***Interactive comment on* “Evaluation of Low Impact Development and Nature-Based Solutions for stormwater management: a fully distributed modelling approach” by Yangzi Qiu et al.**

Received and published: 18 September 2019

Figure 1: Presentation of the simulated hydrographs in whole catchment and in three sub-catchments (a: whole catchment, b: SUB1, c: SUB2, d: SUB3) for the scenario of baseline and porous pavement for the event 05/10/2015.

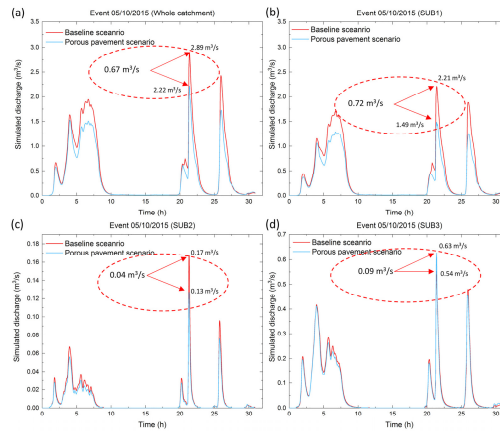
Q1- Uncertainty of the model, the simulations, model structure, X-band radar, down-scaling etc etc. . . the values and ratio, how can 0.1 cms change be really evaluated given the total discharge.

Firstly, the 0.1 cms can absolutely be simulated by Multi-Hydro, whose accuracy is better than 1.5×10^{-4} cms.

Secondly, the 0.1 cms discharge difference between the porous pavement scenario and baseline scenario at the highest rainfall peak of event 05/10/2015 in the sub-catchment (SUB3) is small, but nevertheless represents about 20% of the peak of the baseline scenario and not negligible with respect to those of the largest sub-catchment SUB1 and of the whole catchment. Indeed, they involve factors in the range of 4-7 (see more details in Fig.1, enclosed).
